9/13/96	Class B Concrete changed to Class A.
6/14/96	Notes added to clarify plans.
DATE	REVISION
STATE OF HAWAII DEPARTMENT OF TRANSPORTATION HIGHWAYS DIVISION	
DRAINAGE PLAN	
KALANIANA'OLE HIGHWAY RESURFACING	
Kailua Rd. to Hilo St.	
Project No. 72A-01-96M	
Scale: 1"=40'	Date: May 1996
SHEET No. 44 OF 44 SHEETS

KALANIANA'OLE HIGHWAY RESURFACING

Project No. 72A-01-96M

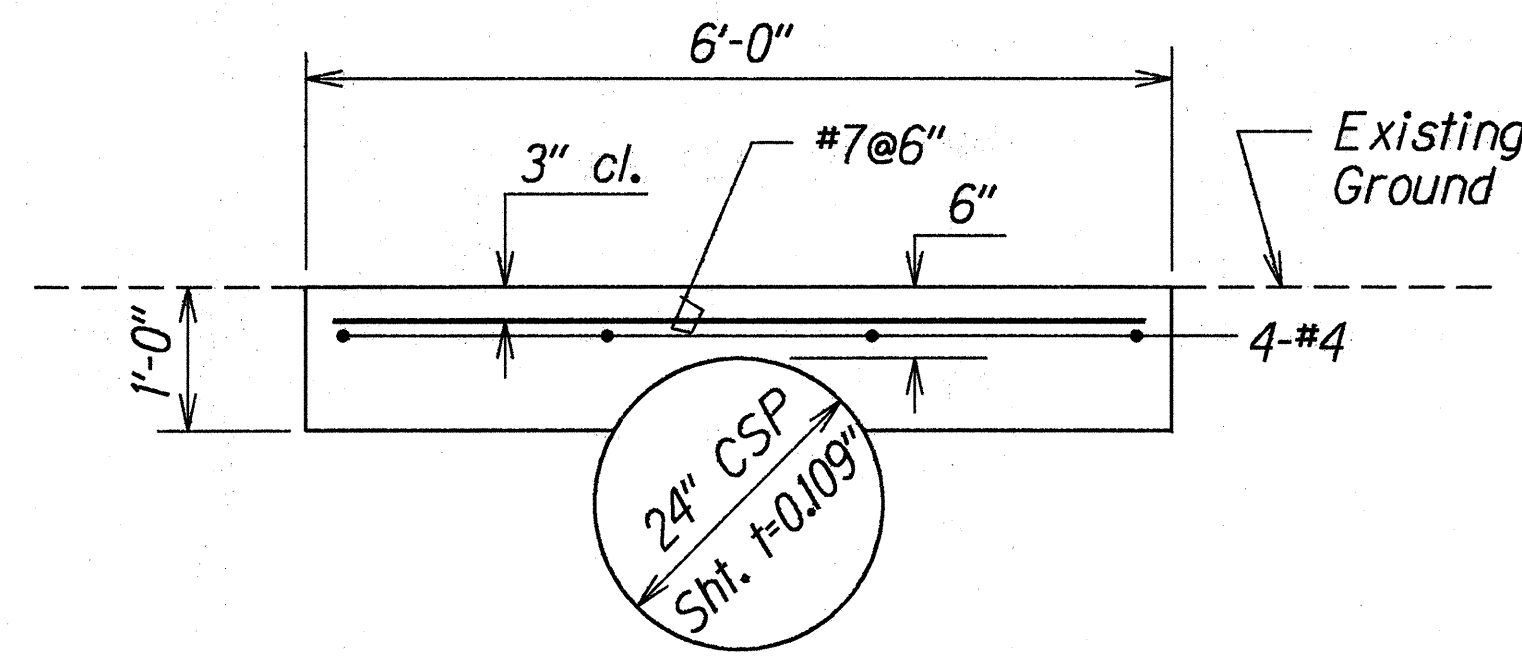
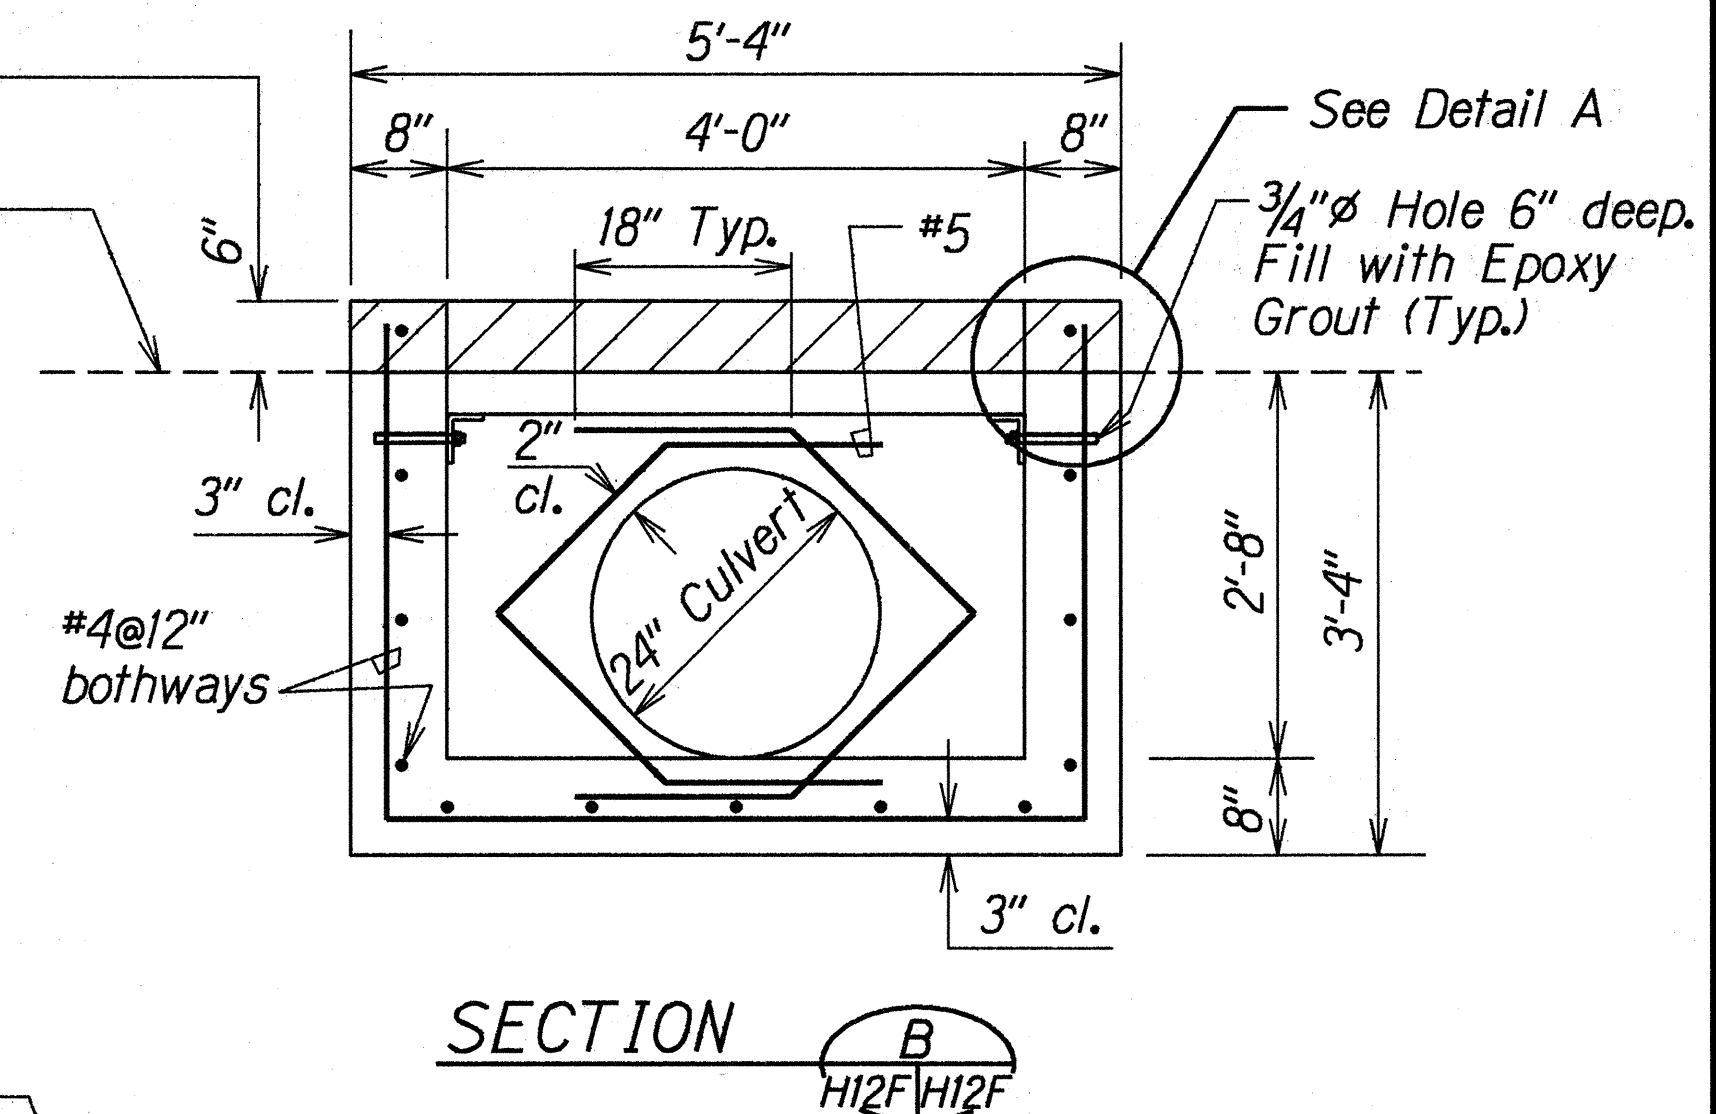
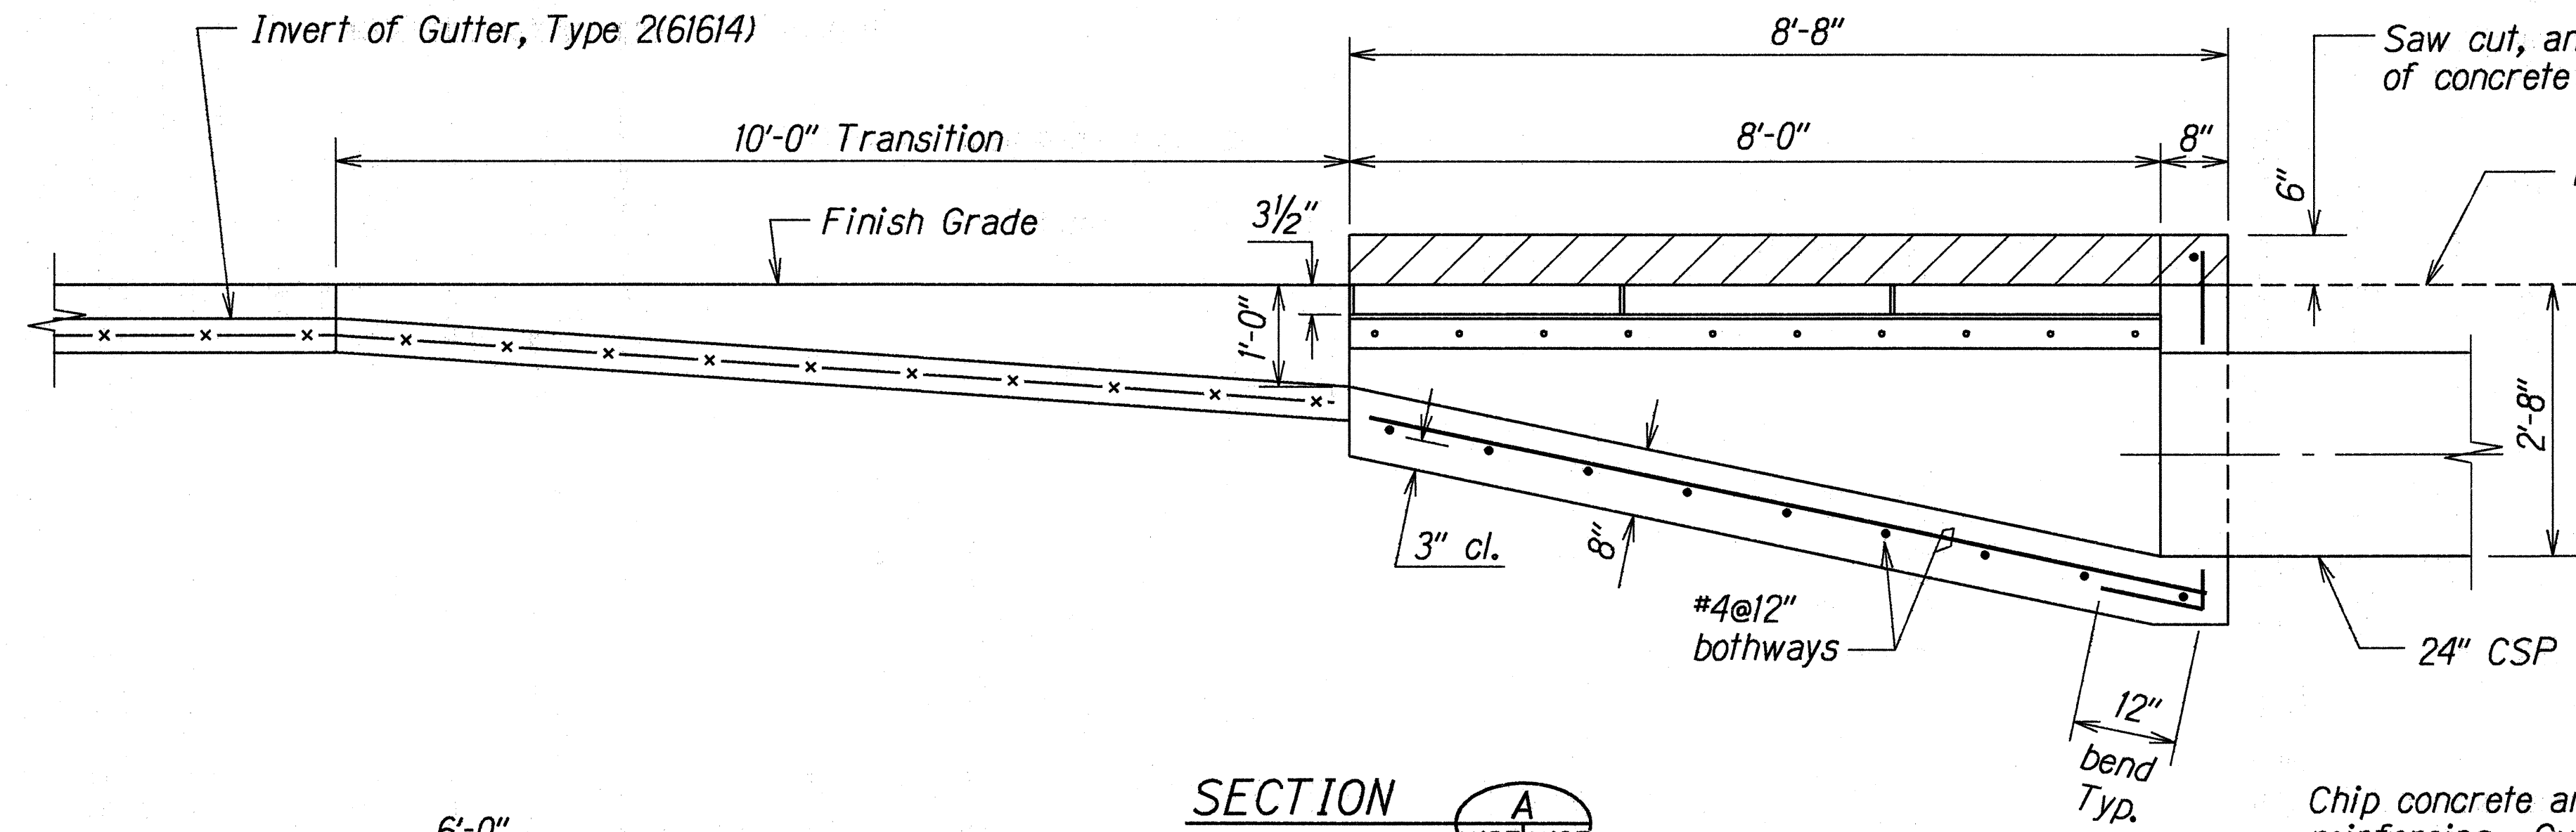
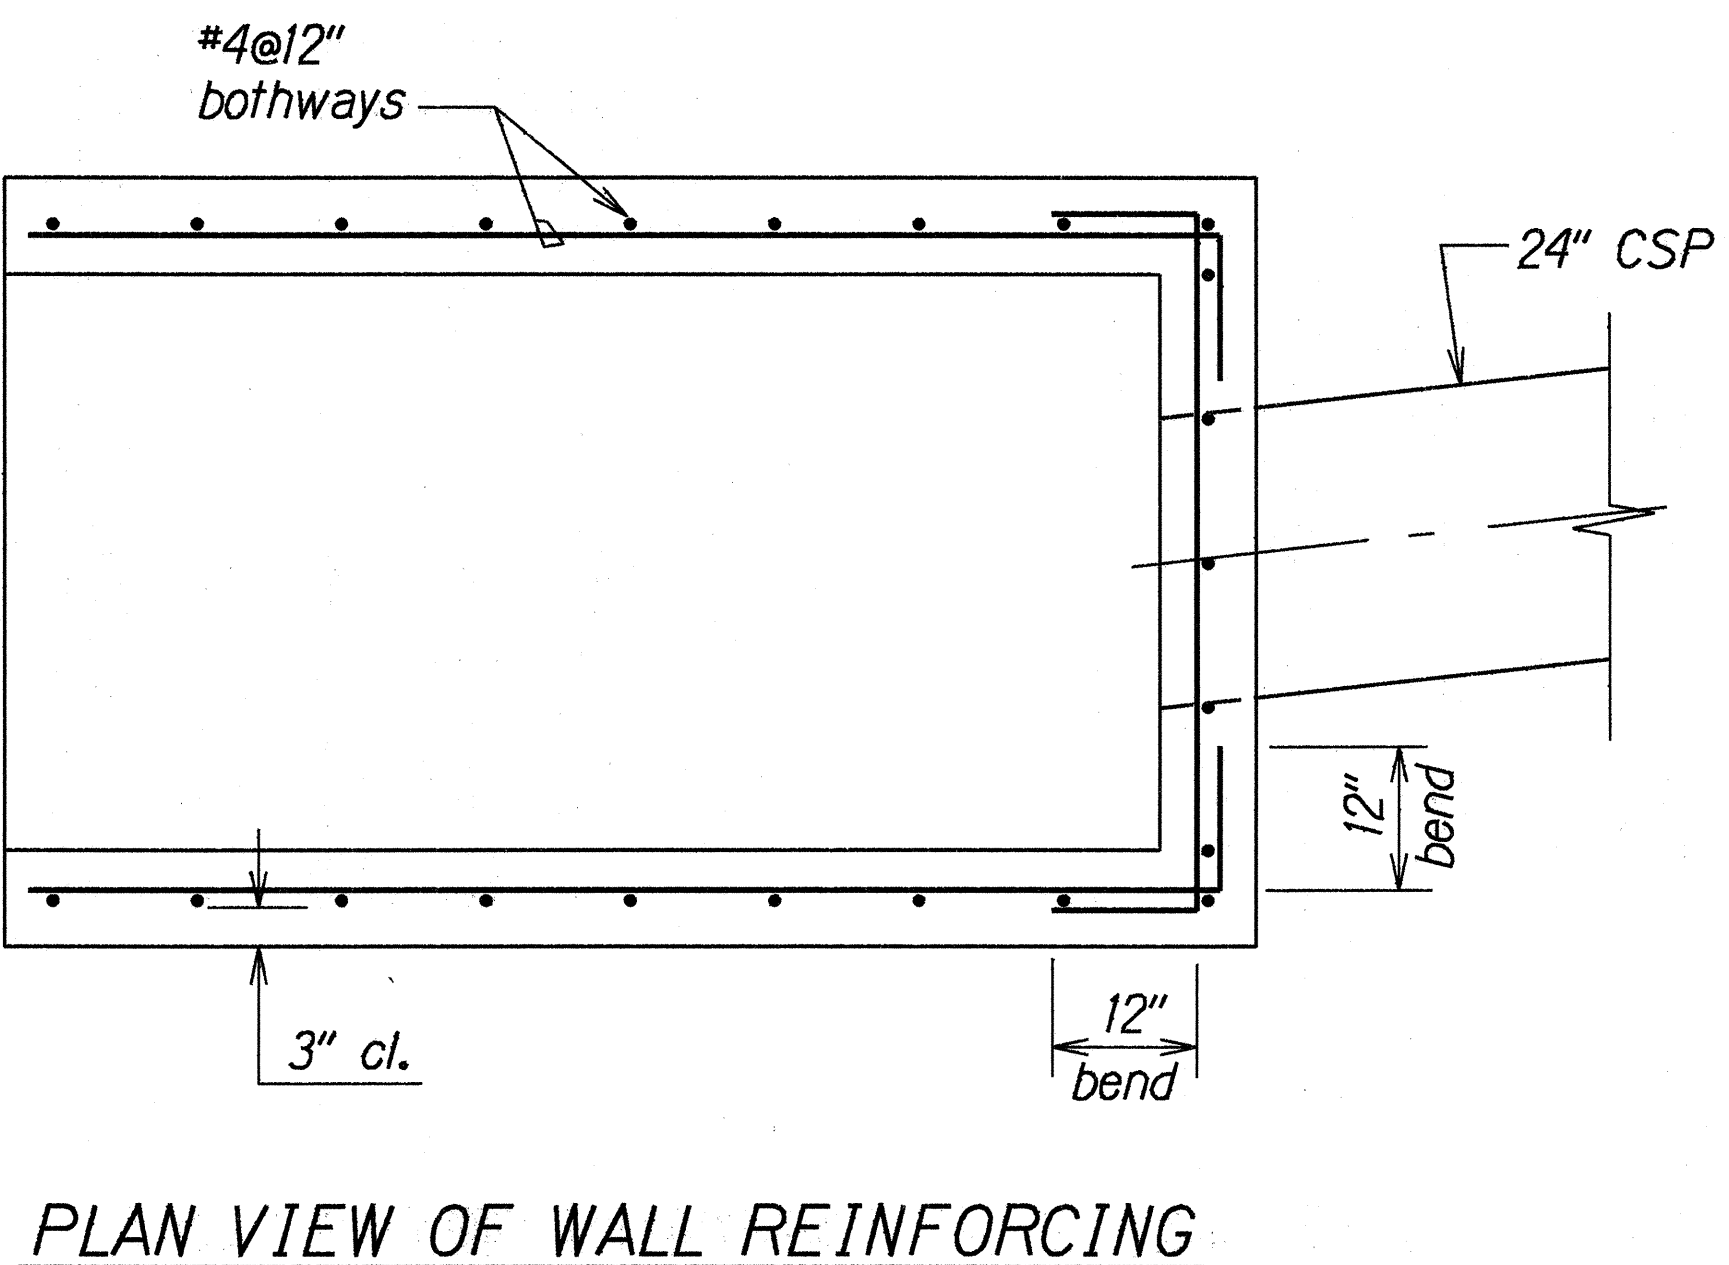
DATE	REVISION
4/15/97	Revised Inlet Structure for safety.
6/14/96	Details added to complete drainage plan.
STATE OF HAWAII DEPARTMENT OF TRANSPORTATION HIGHWAYS DIVISION DRAINAGE DETAILS KALANIANA'OLE HIGHWAY RESURFACING Kailua Rd. to Hilu St. Project No. 72A-01-96M Scale: 3/4"=1'-0" Date: May 1996	
SHEET No. HI2F OF 12 SHEETS

Chip concrete around existing reinforcing. Cut reinforcing bar 1" below saw cut. Fill chipped out area with epoxy mortar.
